Subject: Transmittal of Revision 4 to Service Bulletin V2500-ENG-73-0130.

(1) Change to Effectivity, Incorporation Amendment.

V2500-ENG-73-0130

ENGINE - FUEL AND CONTROL - FUEL SYSTEM AIR TUBES - INTRODUCTION OF REVISED PB
SENSE LINE TUBES WITH INCREASED DIAMETER

Figure 17
Clip point 2166L - Before and after alteration

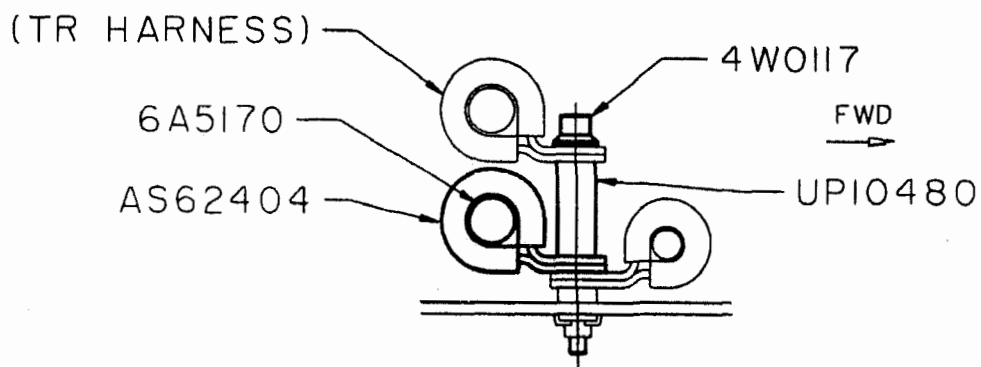
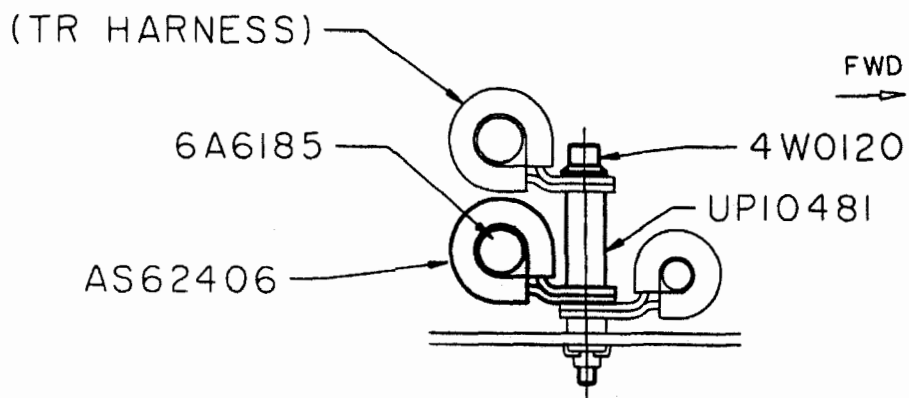
- (i) Disassemble CP2165 and remove and discard bolt AS20912 and clip AS62404. (Refer to Figure 16).
 - (ii) Disassemble CP2166 and remove and discard bolt 4W0117, spacer UP10480 and clip AS62404. (Refer to Figure 17 and 18).

- (d) Connect tube 6A6185 to CP2166. (Refer to Figure 17 and 18).
 - (i) Install clip AS62406 to tube 6A6185 and then assemble CP2166.
- (e) Connect tube 6A6185 to CP2132. (Refer to Figure 8).

Figure 19
Clip point 2171 - Before and after alteration

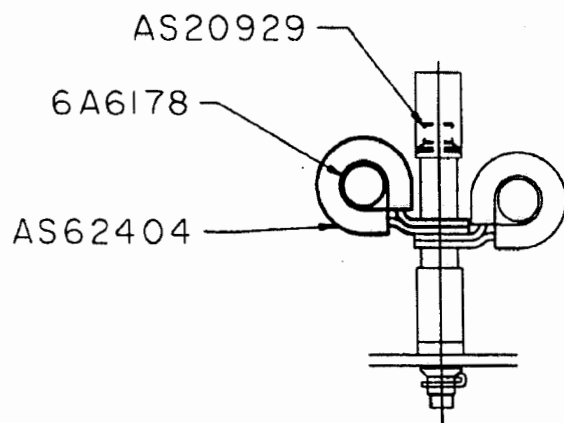
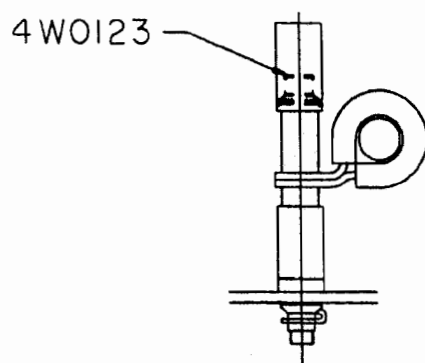
- (ii) Discard bolt AS20929 and clip AS62404.
 - (iii) With bolt 4W0123 and the initial nut, install CP2172 to the bracket.
 - (d) Disconnect CP2171 from tube 6A6178. (Refer to Figure 19)

- (i) Remove CP2171 from the bracket.
 - (ii) Discard bolt AS20918 and clip AS62404.
 - (iii) With bolt 4W0112 and the initial nut, install CP2171 to the bracket.

Figure 20
Clip point 2172 - Before and after alteration

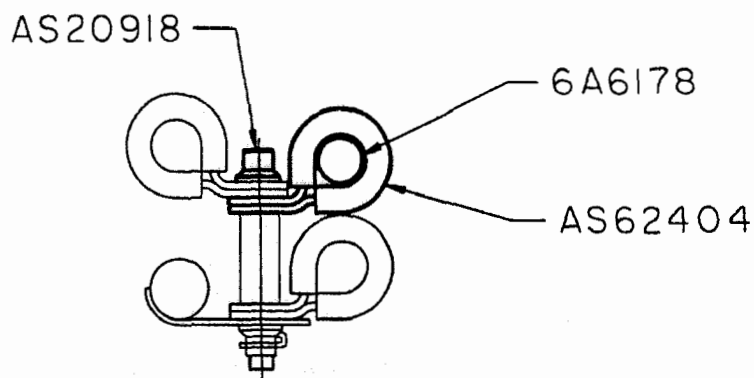
- (b) Disconnect CP2038 from tube 6A6178. (Refer to Figure 4).
 - (c) Disconnect CP2172 from tube 6A6178. (Refer to Figure 20).
 - (i) Remove CP2172 from the bracket.

Figure 21
Clip point 2173 - Before and after alteration

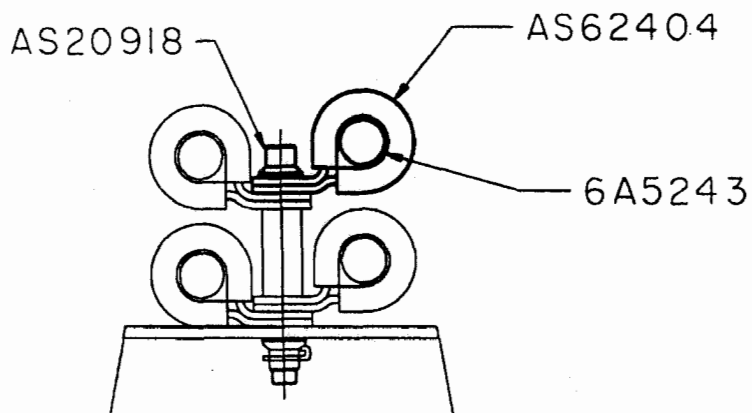
- (d) Disconnect CP2173 from tube 6A5243. (Refer to Figure 21).
 - (i) Disassemble CP2173.
 - (ii) Remove and discard bolt AS20918 and clip AS62404.
 - (iii) With bolt 4W0113 and the initial nut, assemble CP2173.

Figure 22
Clip point 2174 - Before and after alteration

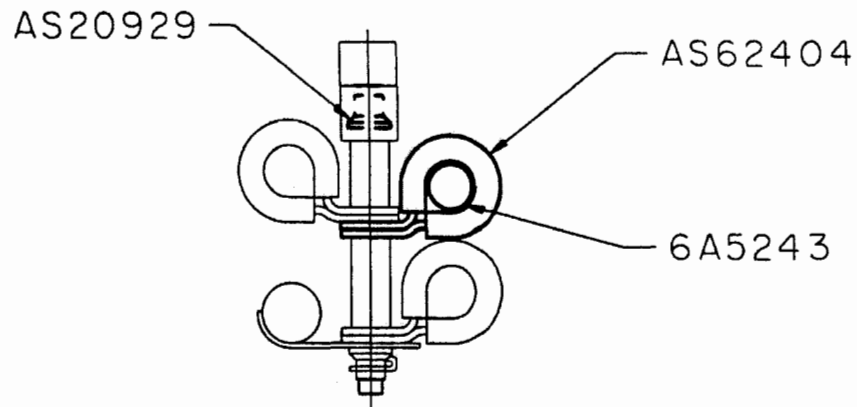
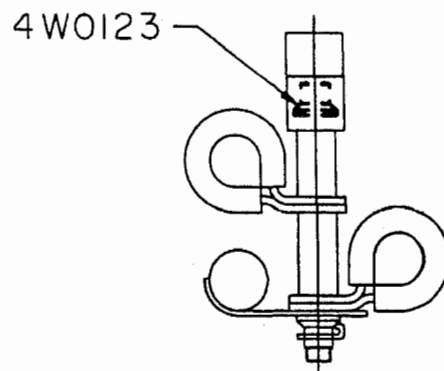
- (ii) Remove and discard bolt AS20918 and clip AS62404.
 - (iii) With bolt 4W0113 and the initial nut, assemble CP2175.
 - (c) Disconnect CP2174 from tube 6A5243. (Refer to Figure 22).

- (i) Disassemble CP2174.
 - (ii) Remove and discard bolt AS20929 and clip AS62404.
 - (iii) With bolt 4W0123 and the initial nut, assemble CP2174.
 - (d) Disconnect CP2173 from tube 6A5243. (Refer to Figure 22).

- (c) Disconnect CP2174 from tube 6A5243. (Refer to Figure 22).
 - (i) Disassemble CP2174.
 - (ii) Remove and discard bolt AS20929 and clip AS62404.
 - (iii) With bolt 4W0123 and the initial nut, assemble CP2174.

Figure 23
Clip point 2175 - Before and after alteration

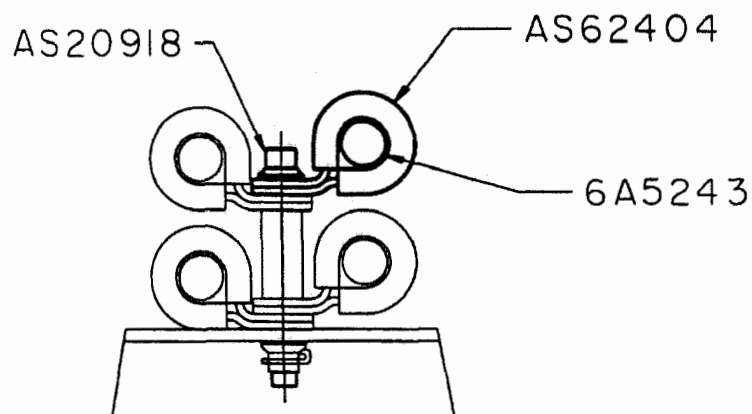
- (ii) Remove and discard bolt AS20948, clip AS62404 and spacer 6A4825.
 - (b) Disconnect CP2175 from tube 6A5243. (Refer to Figure 23).
 - (i) Disassemble CP2175.

- (b) Disconnect CP2175 from tube 6A5243. (Refer to Figure 23).
 - (i) Disassemble CP2175.
 - (ii) Remove and discard bolt AS20918 and clip AS62404.
 - (iii) With bolt 4W0113 and the initial nut, assemble CP2175.

Figure 24
Clip point 2196 - Before and after alteration

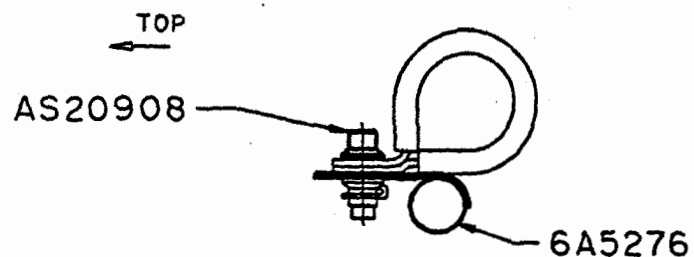
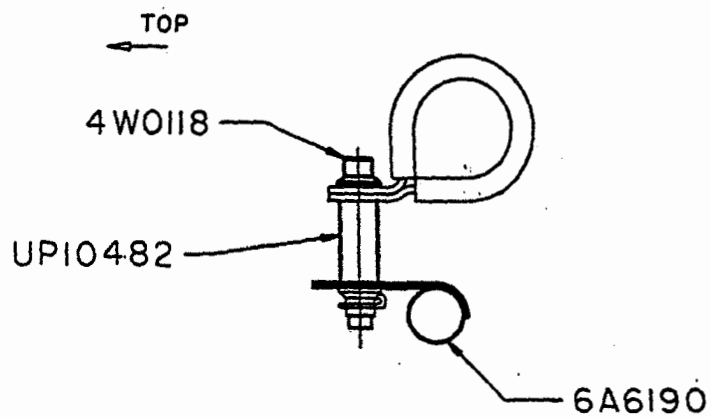
- (i) Remove and discard the bolt AS20920 from CP2147. (Refer to Figure 15).
 - (ii) Remove and discard the bolts AS20908 from CP2196 and CP2198. (Refer to Figures 24 and 25).

- (i) With the bolt 4W0115 and the initial nut, install CP2147. (Refer to Figure 15).
- (ii) With the bolt 4W0118, the spacer UP10482 and the initial nut, install CP2195. (Refer to Figure 24).

Figure 25
Clip point 2198 - Before and after alteration

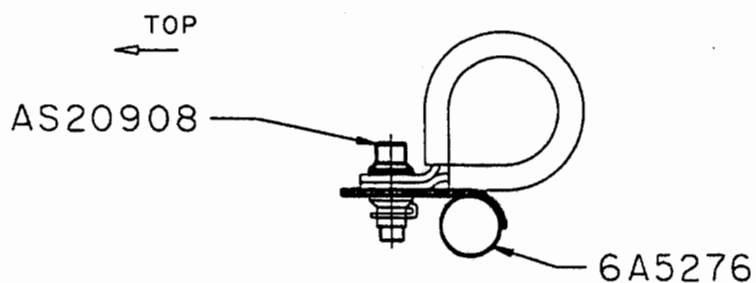
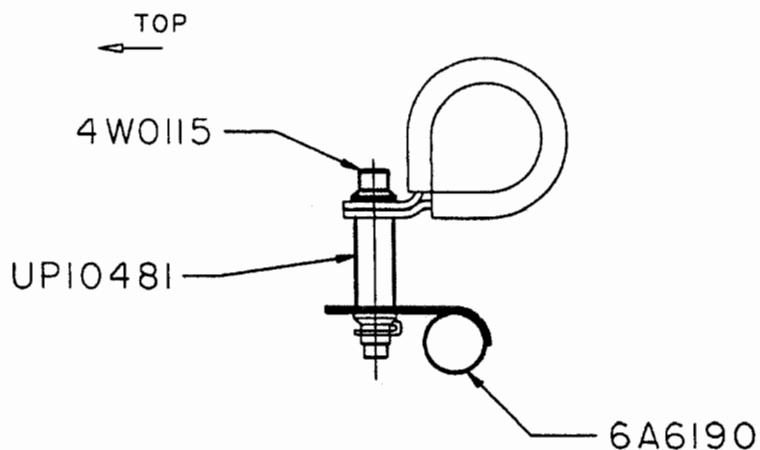
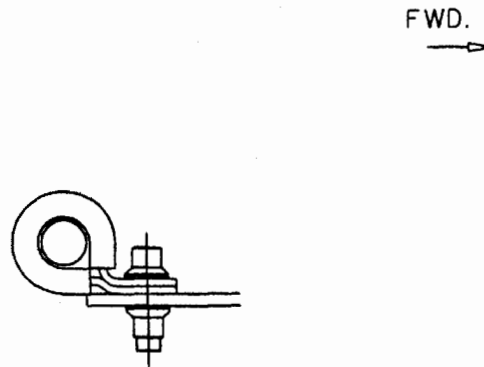
- (iii) With the bolt 4W0115, the spacer UP10481 and the initial nut, install CP2198. (Refer to Figure 25)
- (b) Install CP2694 to 6A6190, Harness A and the vibration transducer loom. (Refer to Figure 37).

Figure 26
Clip point 2331 - Before and after alteration

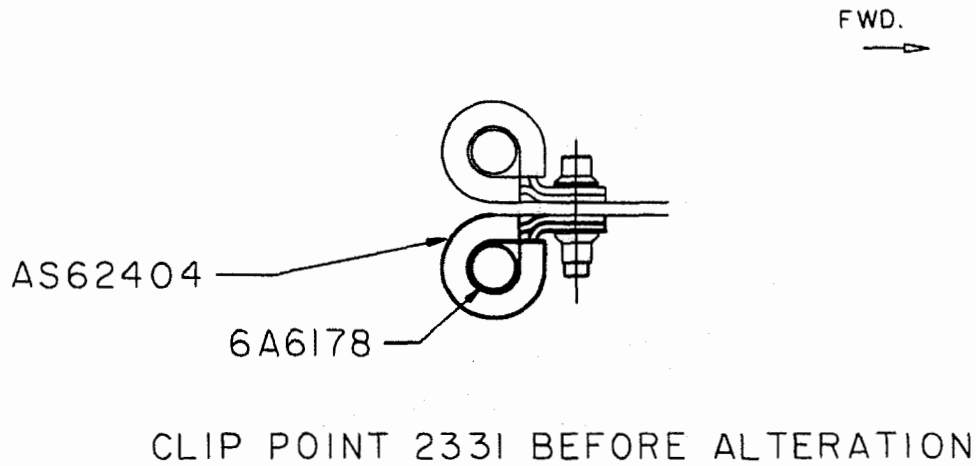
- (ii) Discard bolt AS20908, clip AS62404 and nut 4W0001.
 - (iii) With bolt 4W0102 and nut 4W0043, install CP2444 to the bracket.
 - (j) Disconnect CP2331 from tube 6A6178. (Refer to Figure 26).

- (i) Remove CP2331 from the bracket.
 - (ii) Discard clip AS62404.
 - (iii) With the initial bolt and nut, install CP2331 to the bracket.
 - (k) Disconnect tube 6A6178 from tube assembly 6A6177 and discard the tube.

Figure 27

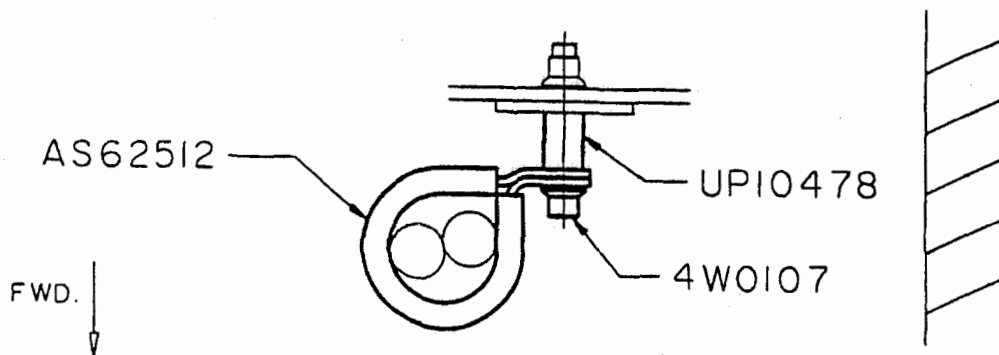
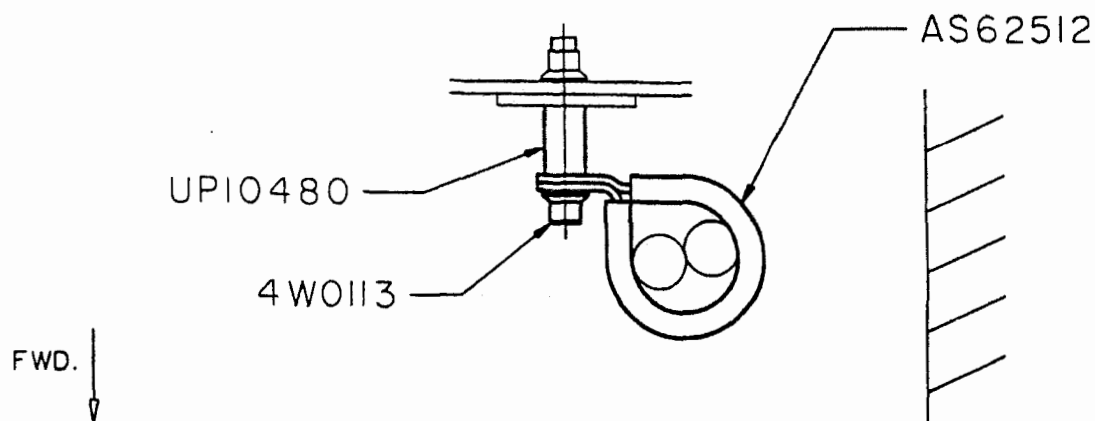
- (m) For the right engine only, move clip AS62512 to a different position at CP2351R. (Refer to Figure 27).
 - (i) Disassemble CP2351R.
 - (ii) Remove and discard bolt 4W0107 and spacer UP10478.

- (iii) Remove clip AS26512 from the harness. Turn clip AS26512 through 180 degrees and then install it again on the harness.
 - (iv) With the new bolt 4W0113, new spacer UP10480 and the initial nut, install CP2351R to the bracket.

Figure 28
Clip point 2351L - Before and after alteration

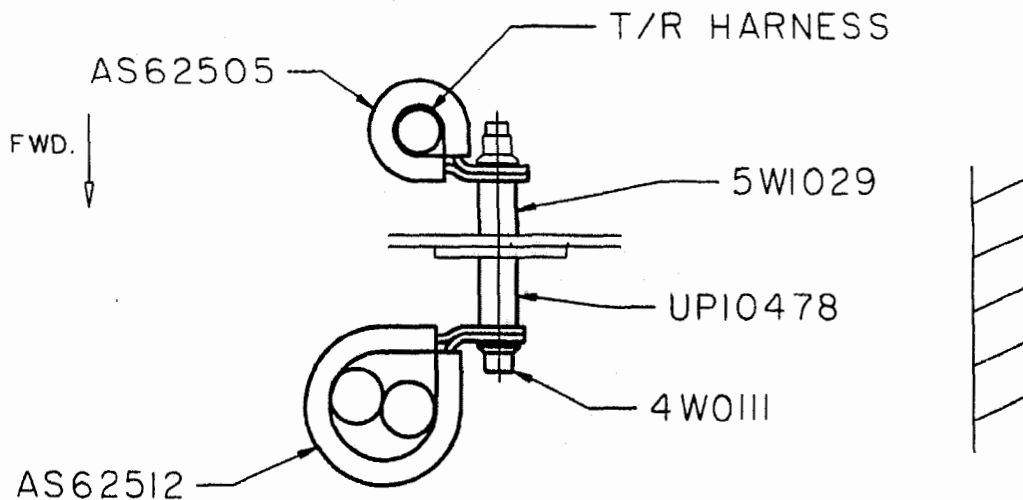
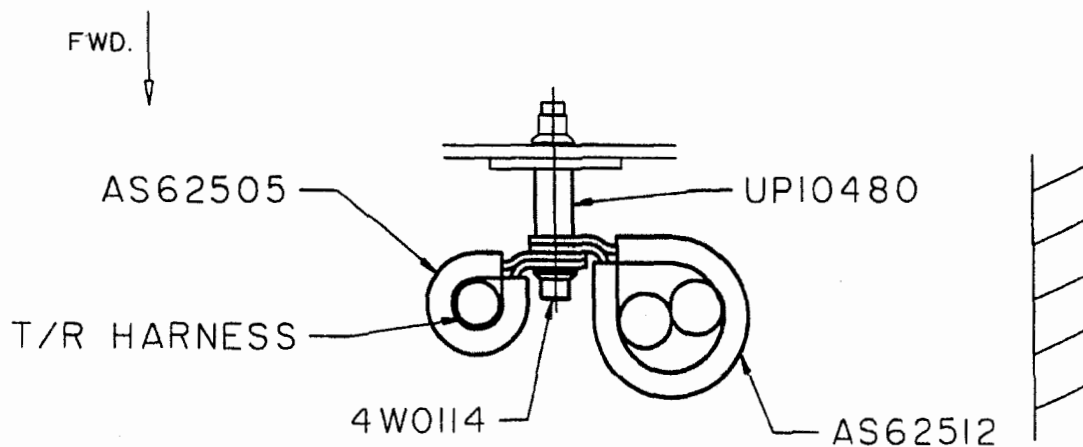
- (l) For the left engine only, move the thrust reverser harness to a different position at CP2351L. (Refer to Figure 27).
 - (i) Disassemble CP2351L, then remove and discard bolt 4W0111 and spacer UP10478.

- (ii) Remove clip AS26512 from the harness. Turn clip AS26512 through 180 degrees and then install it again on the harness.
 - (iii) With bolt 4W0114, spacer UP10480 and the initial nut, assemble CP2351L.

Figure 29
Clip point 2444 - Before and after alteration

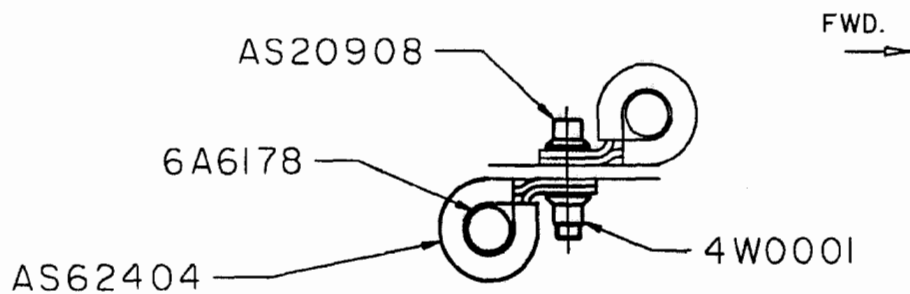
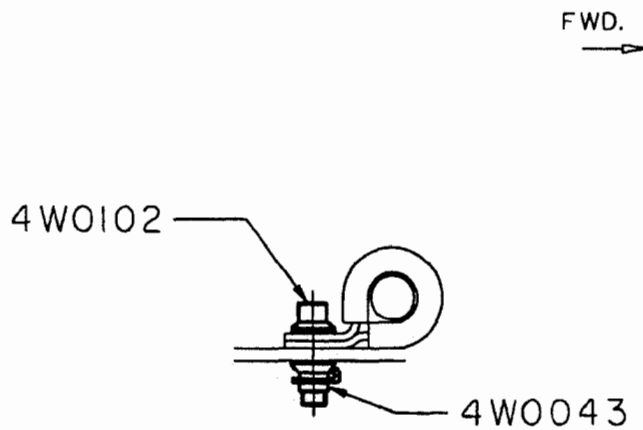
- (iii) With bolt 4W0103 and nut 4W0043, install CP2513 to the bracket.
 - (i) Disconnect CP2444 from tube 6A6178. (Refer to Figure 29).
 - (i) Remove CP2444 from the bracket.

Figure 30
Clip point 2512L - Before and after alteration

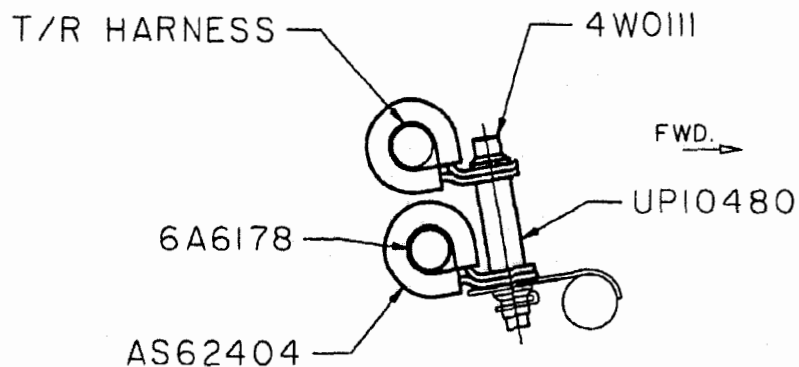
- (e) For the left engine only, disconnect CP2512 from tube 6A6178. (Refer to Figure 30).
 - (i) Remove CP2512 from the bracket.
 - (ii) Discard bolt 4W0111, spacer UP10480 and clip AS62404.

- (iii) With bolt 4W0102 and the initial nut, install CP2512 to the bracket.
 - (f) For the right engine only, remove and discard CP2512.
 - (g) For the left engine only, disconnect CP2513 from tube 6A6178 as follows. (Refer to Figure 32):

Figure 31
Clip point 2513R - Before and after alteration

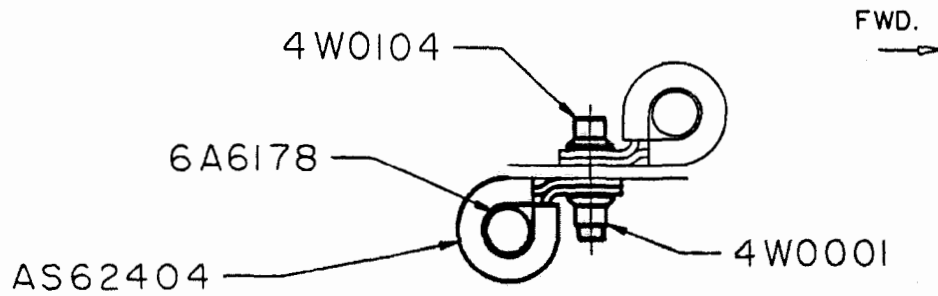
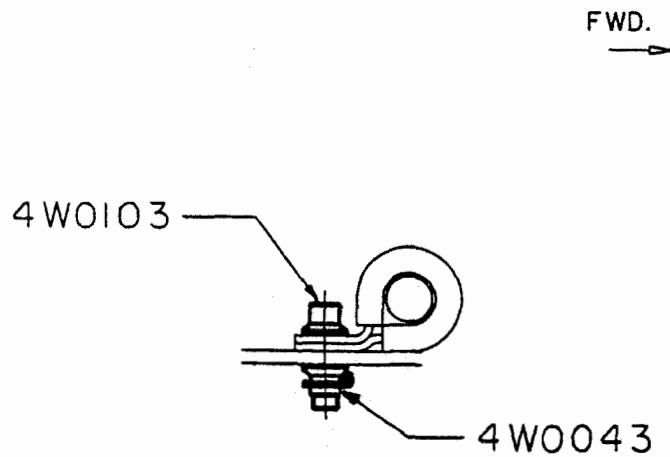
- (h) For the right engine only, disconnect CP2513 from tube 6A6178 as follows. (Refer to Figure 31):
 - (i) Remove CP2513 from the bracket.
 - (ii) Discard bolt 4W0104, clip AS62404 and nut 4W0001.

Figure 32
Clip point 2513L - Before and after alteration

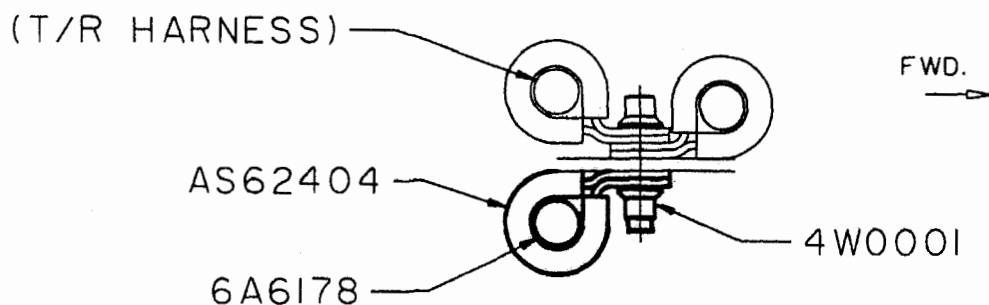
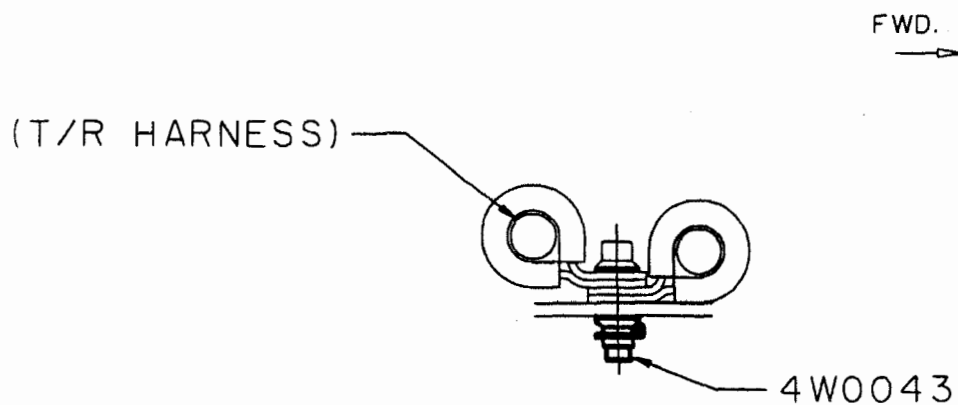
- (i) Remove CP2513 from the bracket.
 - (ii) Remove and discard nut 4W0001 and clip AS62404.
 - (iii) With the new nut 4W0043 and the initial bolt, assemble CP2513 to the bracket.

Figure 33
Clip point 2636 - Before and after alteration

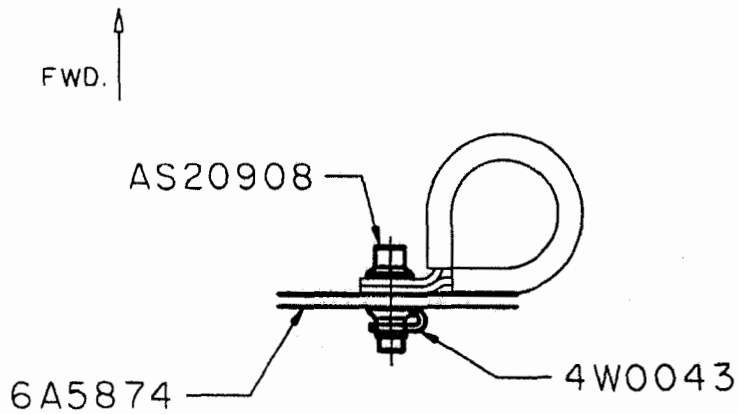
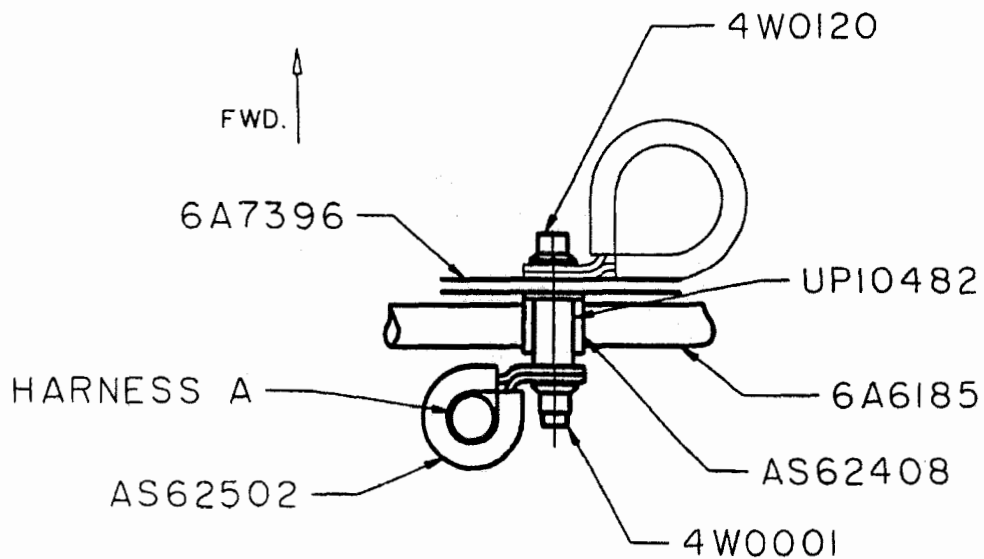
- (6) Install tube 6A6185 between tube 6A6186 and the Pb connector of the bifurcation panel. (Refer to Figures 2, 5, 8, 10, 16, 17, 18 and 33).
 - (a) Connect tube 6A6185 to CP2636. (Refer to Figure 33).

- (i) Disassemble CP2636 and discard the bolt AS20908 and the nut 4W0043.
 - (ii) Replace bracket 6A5874 with bracket 6A7396. (Refer to Figure 2). (For the correct removal/installation procedures refer to the MD-90 Engine Manual (EM), Chapter/Section 72-00-32, Removal-05 CONFIG-1 and CONFIG-2 and Installation-01 CONFIG-2 and CONFIG-3).

Figure 34
Clip point 2688 and 2689 - Added

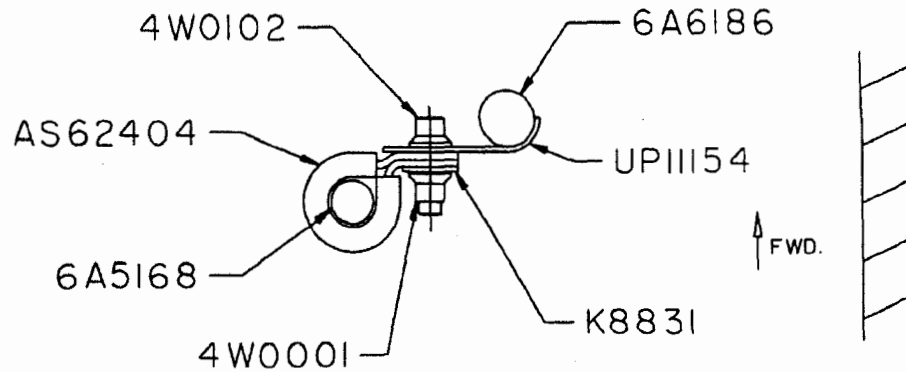
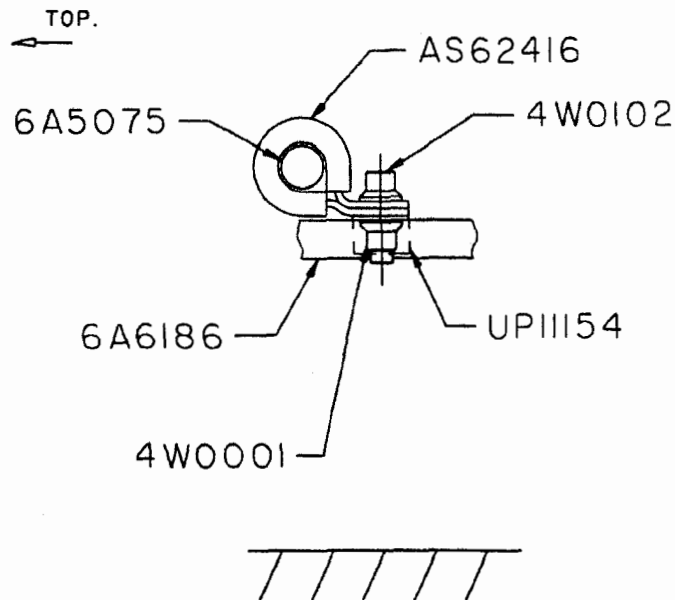
- (g) Install clip AS62406 to tube 6A6186 and then connect the clip to CP2689. (Refer to Figure 34).

- (h) Install clip AS62404 to tube 6A6186 and then connect the clip to CP2688. (Refer to Figure 34).
- (i) Connect tube 6A6186 to CP2118 and CP2122. (Refer to Figures 6 and 7).
